ADDENDUM NO. 1

PROJECT: Senior Center Activity Building Plumbing Renovation

SENIOR CENTER ACTIVITY BUILDING PLUMBING RENOVATION

PARTIAL PLUMBING PLAN
1/2" = 1'-0"

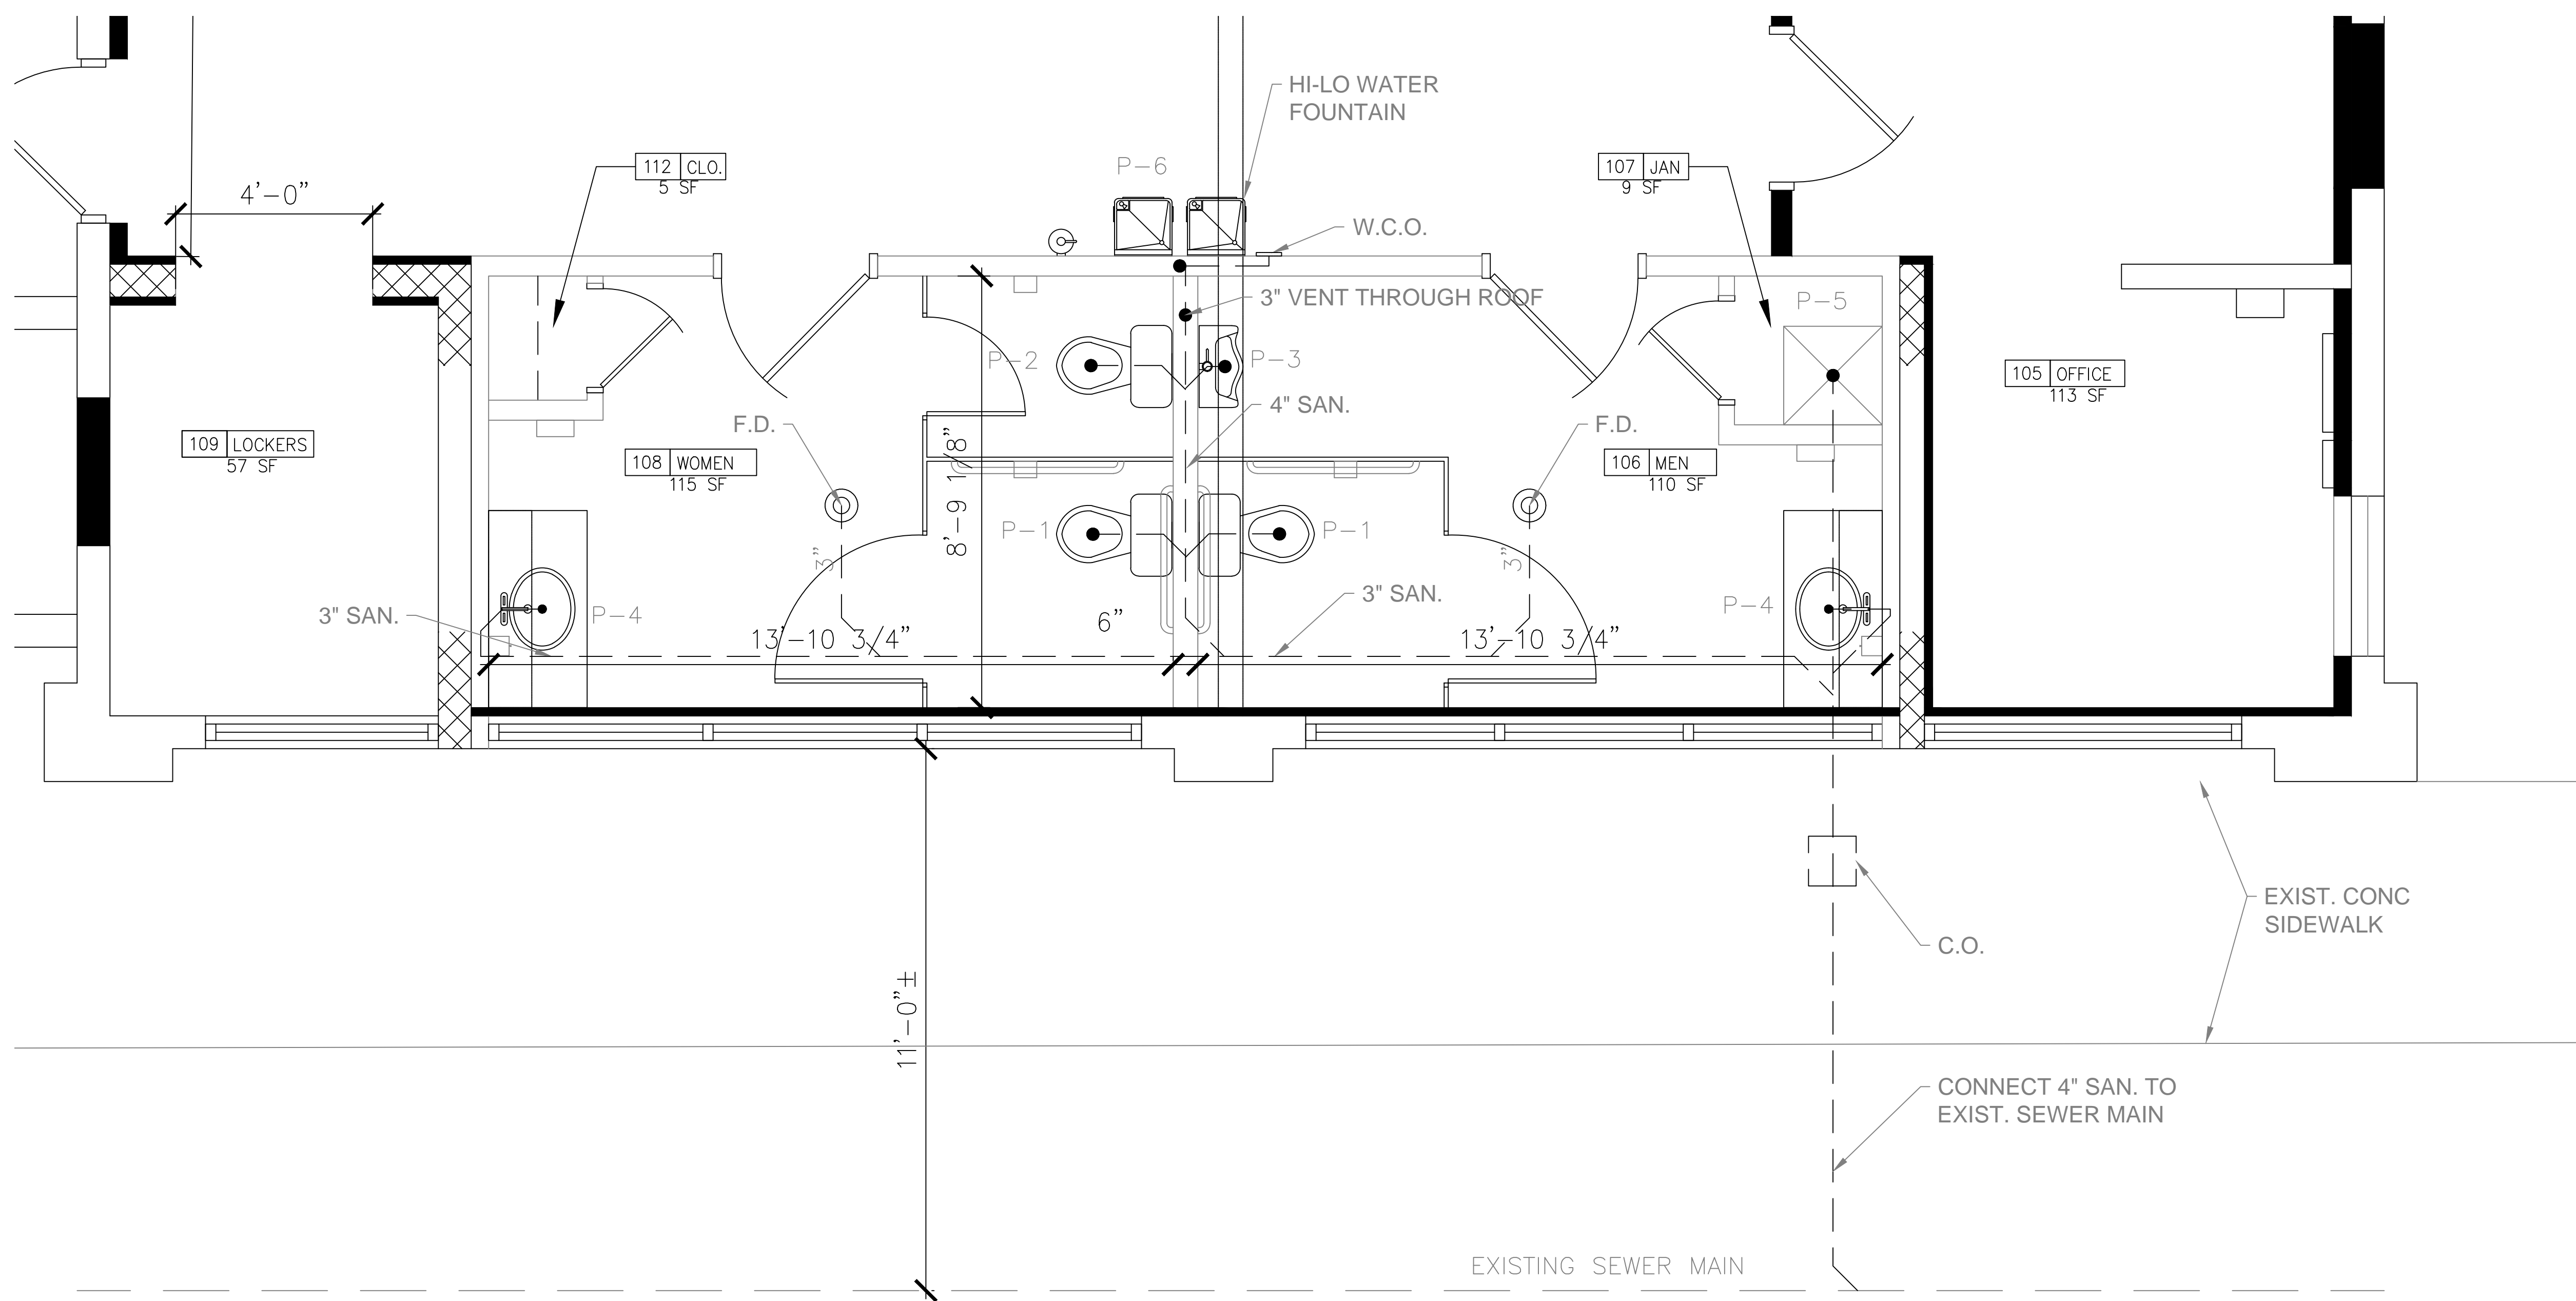
Inquiry No. 7: Please furnish the “plans” as referenced in Scope of Work (SOW) that show locations of interior and exterior cleanouts.

Inquiry No. 8: Please show the proposed new location of existing overhead water piping. This piping shall be relocated as referenced in SOW. Is the existing overhead water line branch that goes to the existing outdoor hydrant, remaining in its present location?

Response: Plans referenced in the Summary of work have been attached to this addendum as requested. (See attachment No. 1.)

Response: The existing outdoor hydrant shall remain in place and shall remain fully functional. The existing water line that runs parallel to the existing roof joists shall be relocated a minimum of three joist bays closer to the storefront side of the building to allow for installation of a new roof top HVAC unit.

Elkay ezH2O Bottle Filling Station with Mechanically Activated Bi-Level ADA Cooler Filtered Refrigerated Light Gray Model LMABFTL8WSLK

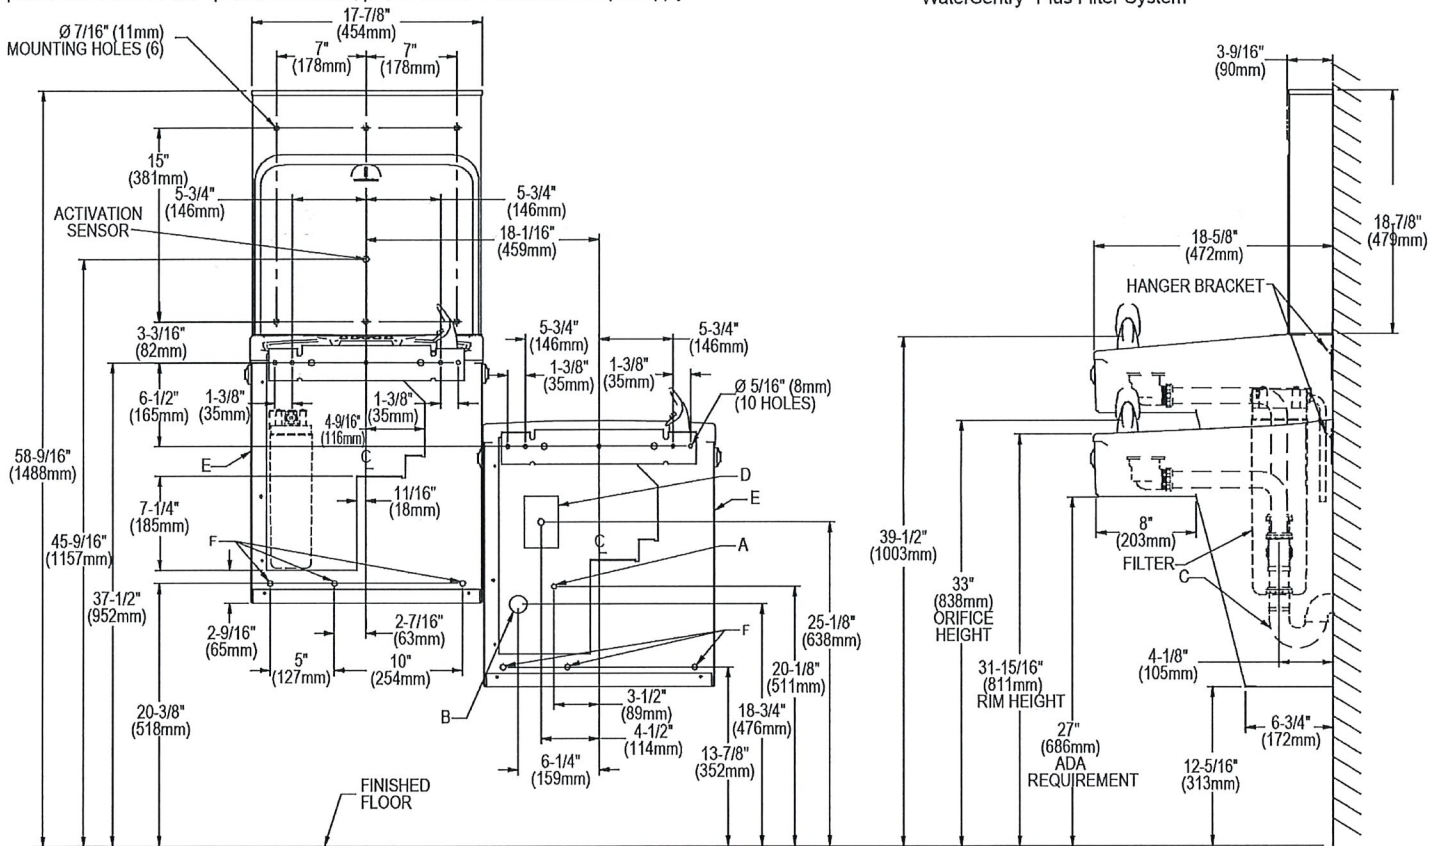
Inquiry No. 11: SOW states: bi-level refrigerated electric water cooler with bottle filler. Attachment 4 shows a bi-level non-refrigerated electric water cooler with bottle filler. Please advise whether this water cooler shall be refrigerated or non-refrigerated.

Response: The water cooler will be filtered and refrigerated. A revised “P-6” fixture specification sheet has been provided with this addendum. (See attachment No. 2)
